**RE: 12RFP112311K-NH Medical and Office Furniture, Fixtures & Equipment Design and Installation for the Adamsville Regional Health Center**

**12RFP112311K-NH Medical and Office Furniture, Fixtures & Equipment Design  
and Installation for the Adamsville Regional Health Center  
Addendum No. 3  
Page Two**

This Addendum forms a part of the contract documents and **modifies** the original RFP documents as noted below:

**12A02-1**

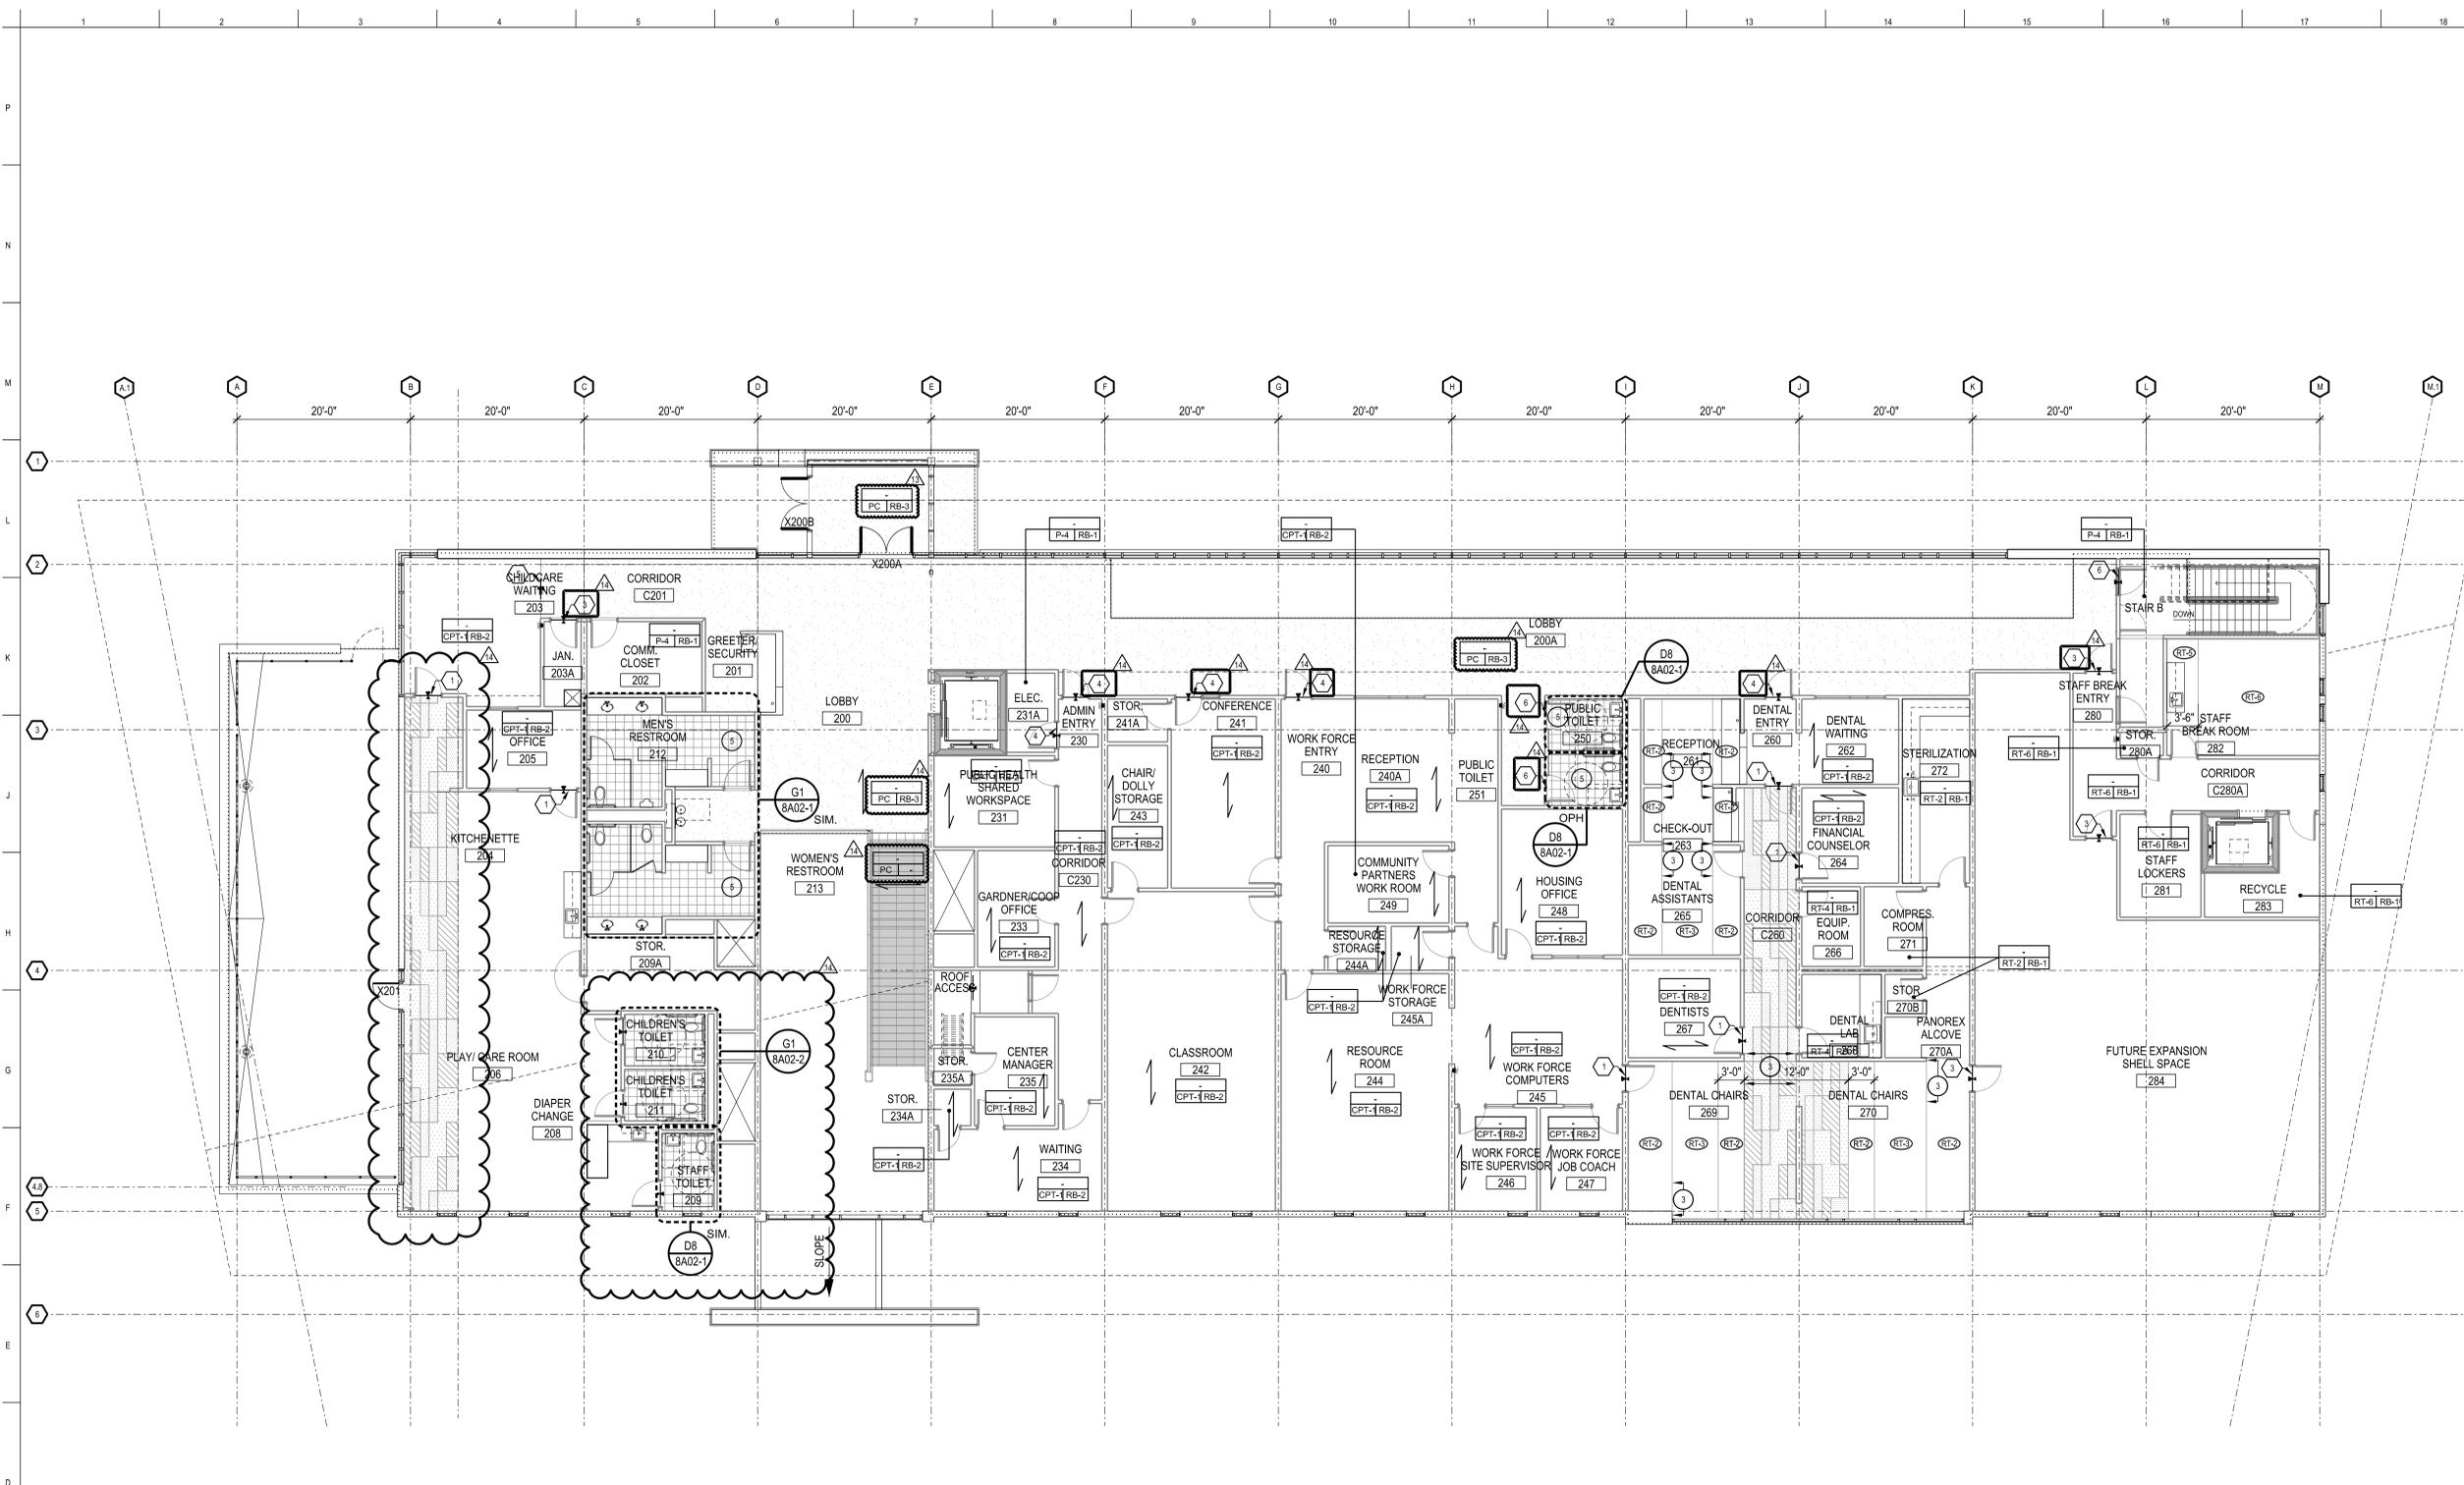
14	12A02	Second Floor Wall Finish Plan		ADDED Polished concrete abbreviation and symbol to legend REVISED Finish tags for revised floor plan layout at Diaper Change 208, Stor. 209A, Toilets 209, 210 and 211 REVISED Key Notes 4 and 6
14	12A02-1	Second Floor Floor Finish Plan		ADDED Polished concrete abbreviation and symbol to legend REVISED Key Notes 4 and 6 REVISED Lobby stair finish, pattern and tag REVISED Transition types where indicated REVISED Rubber base type where indicated REVISED Floor pattern in Playcare Room 206 REVISED Floor plan layout at Diaper Change 208, Stor. 209A, Toilets 209, 210 and 211
